CHARTER TOWNSHIP OF GARFIELD PLANNING COMMISSION MEETING

Wednesday, June 8, 2022 at 7:00 pm
Garfield Township Hall
3848 Veterans Drive
Traverse City, MI 49684
Ph: (231) 941-1620

Charter Township of Garfield	
		Planning Department Report No. 2022-47	
Prepared:	June 1, 2022	Pages:	10
Meeting:	June 8, 2022 Planning Commission	Attachments:	<input checked="" type="checkbox"/>
Subject:	Life Story Crematorium I-G Conditional Rezoning – Findings of Fact		
File No.	Z-2022-01	Parcel No.	05-024-019-30
Owner:	LeVon M. Seavolt “Vaughn”		
Applicant:	LMS Property, LLC

SHEET NO: PP-2.1

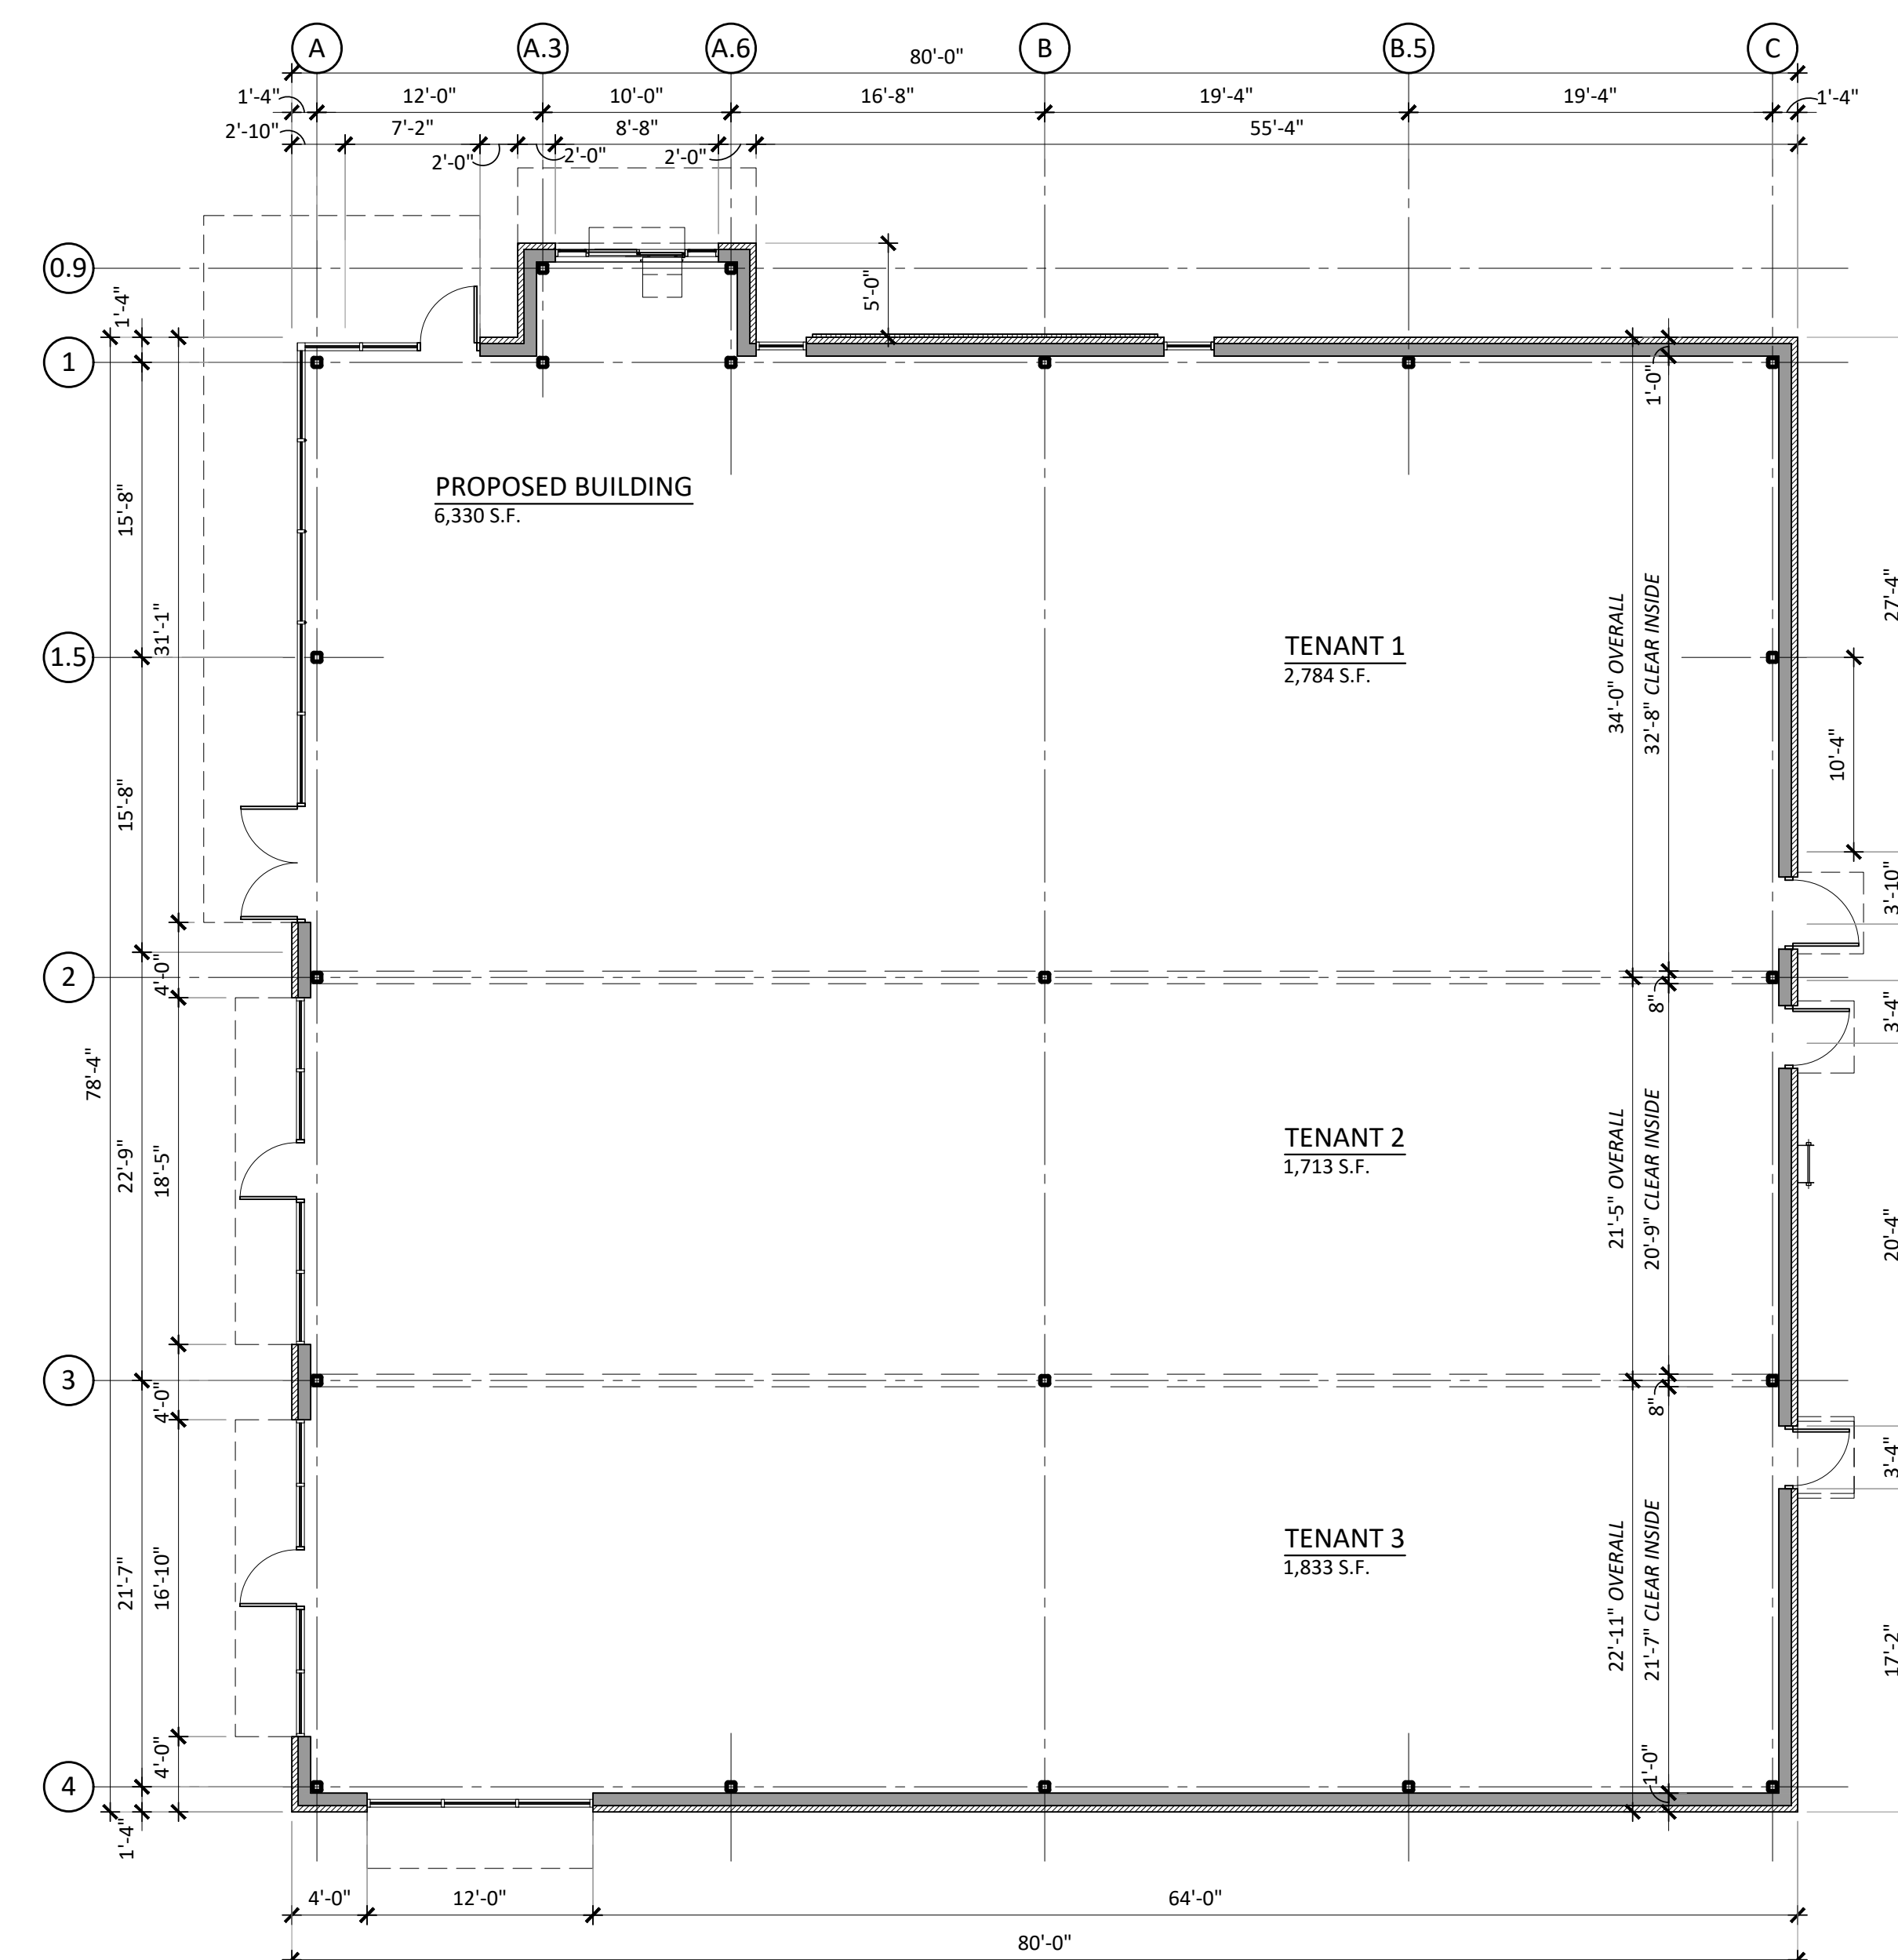
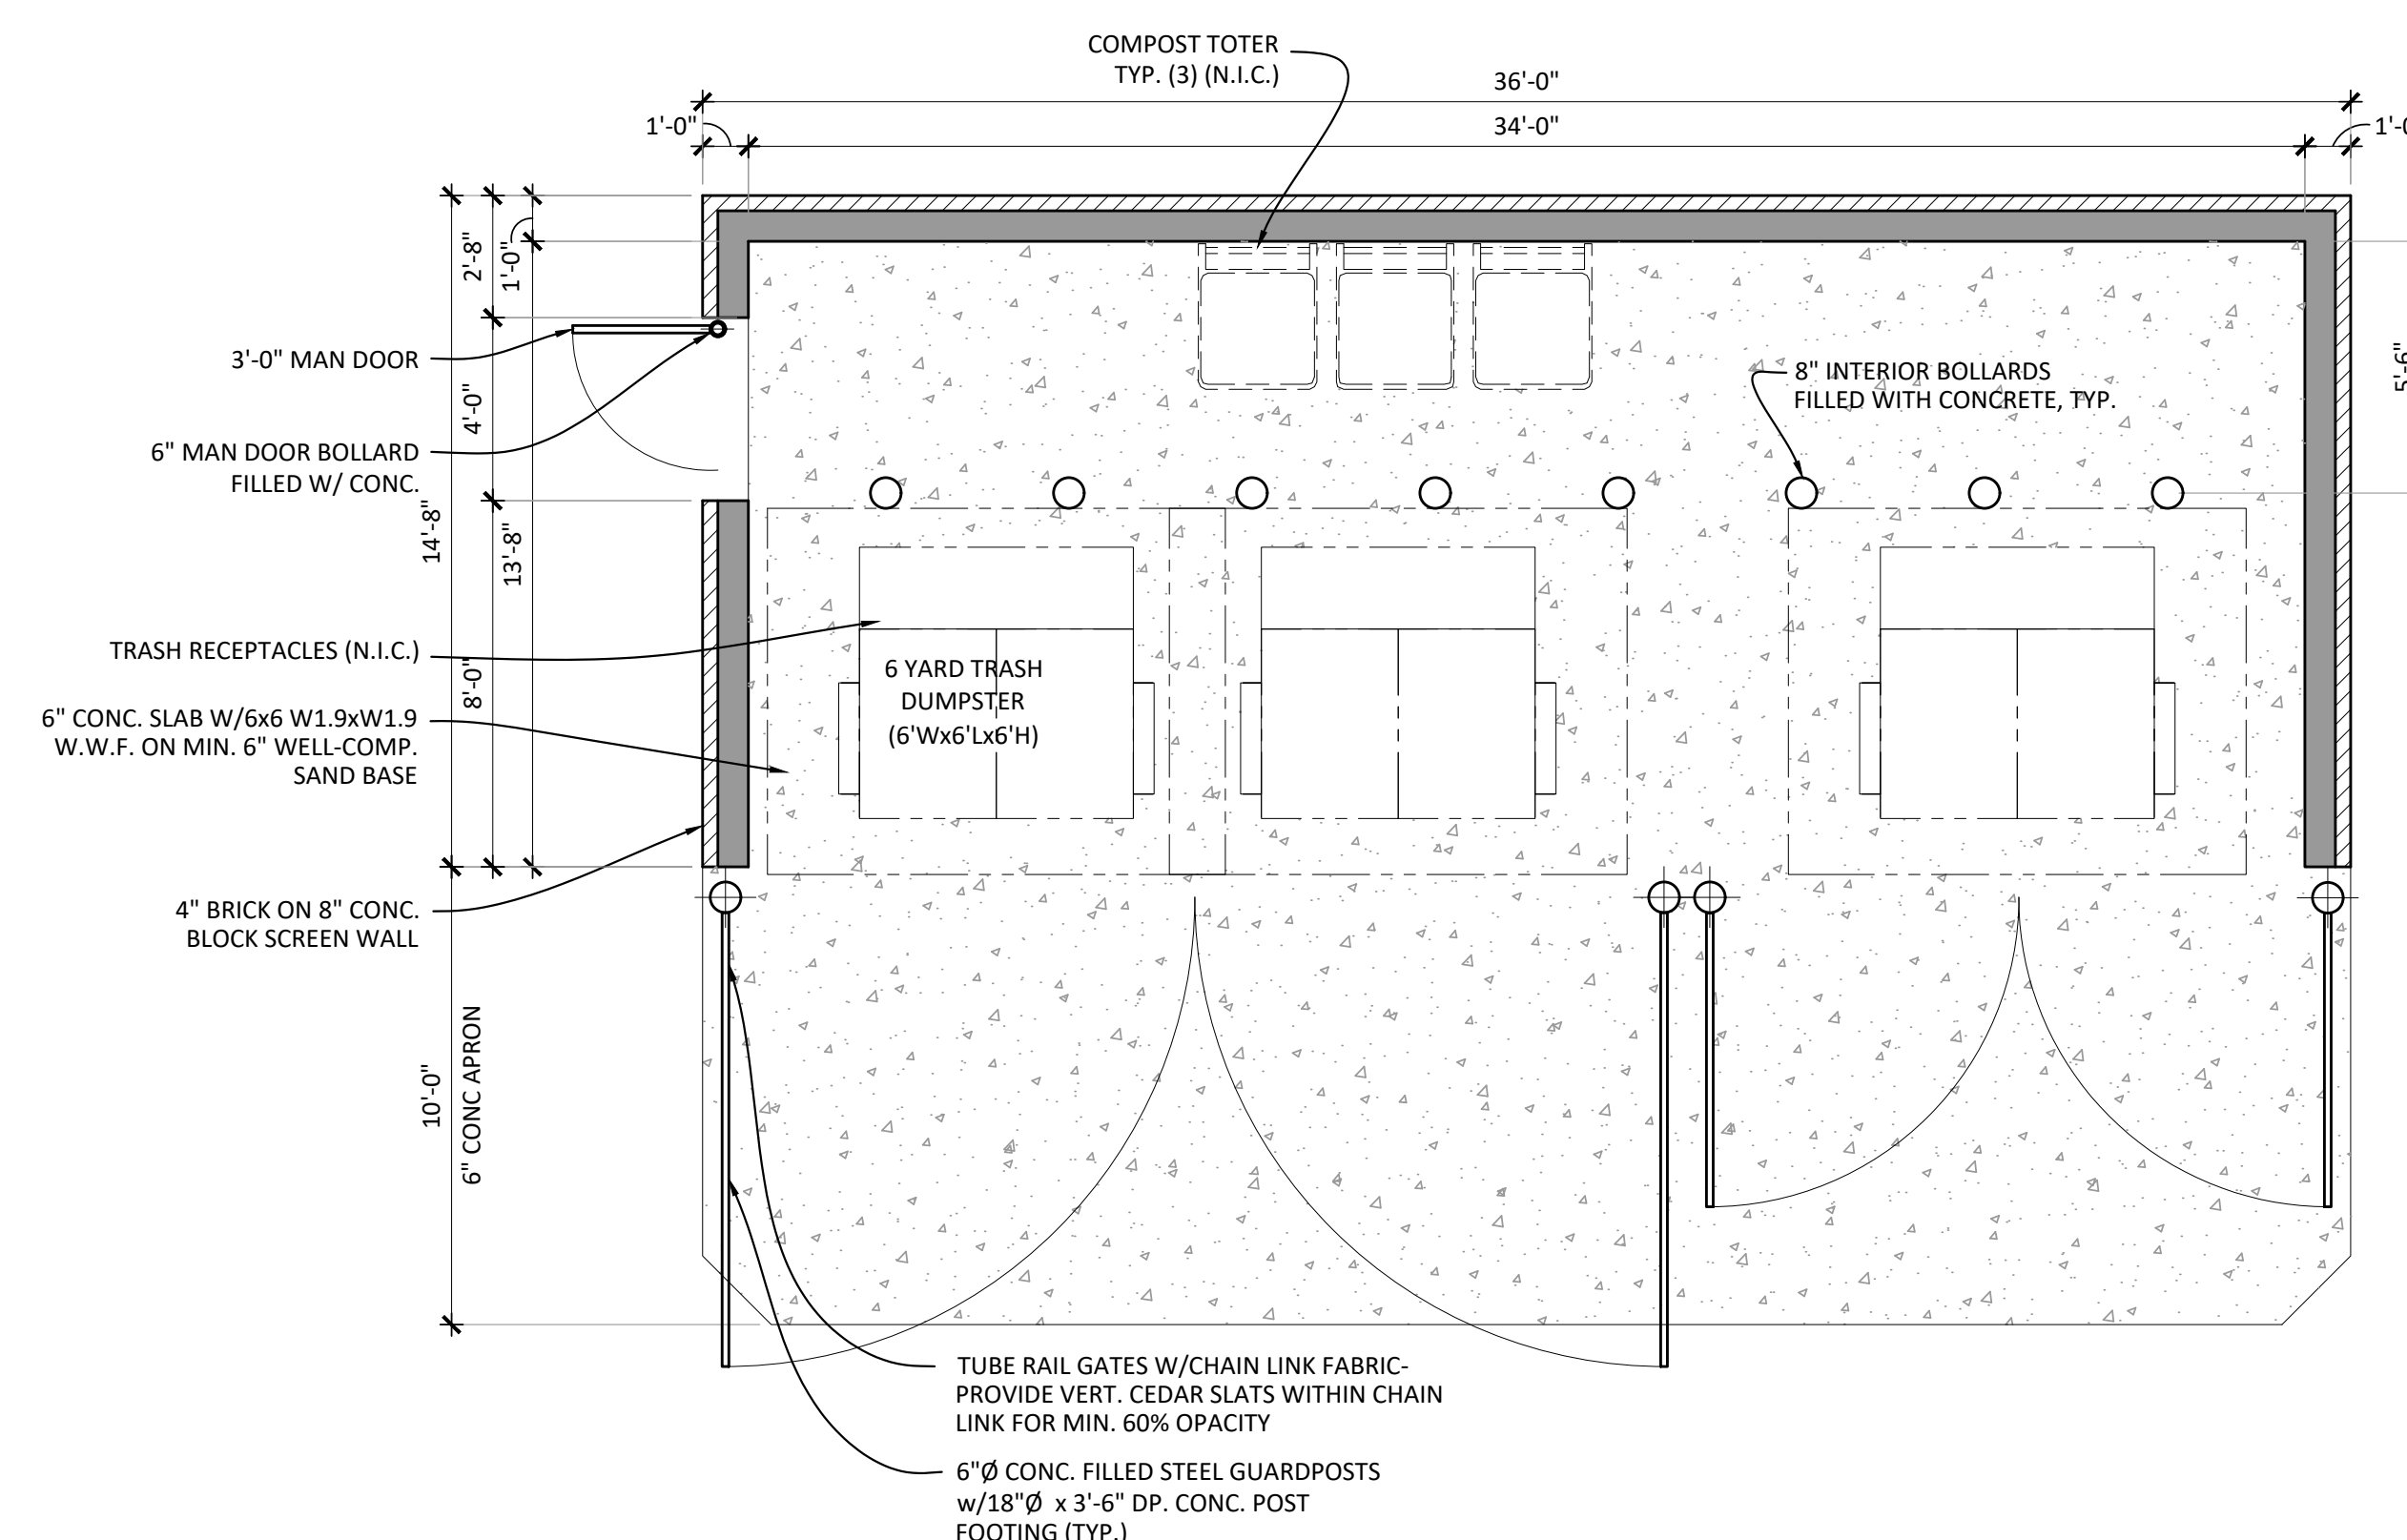
Details for the proposed trash enclosure are included on Sheet PP-2.1. The proposed enclosure area will be 36 feet by 14 feet, 8 inches with space for three dumpsters and a compost area. The wall will have a 4-inch brick façade on 8-inch concrete. The gate will be chain link with cedar slats.

Signs require sign permit review and are not approved under the site plan review process. Proposed signs are shown on Sheet PP-2.1 including a ground sign with space for 3 tenants. A note on Sheet C-3 indicates that “proposed signs are subject to sign permit review.” In conjunction with the shared drive, the parcels behind the site to the east retained the ability to have signage on US 31. These provisions shall be reviewed during as part of the sign permit review process, including any provisions for multi-tenant signage.
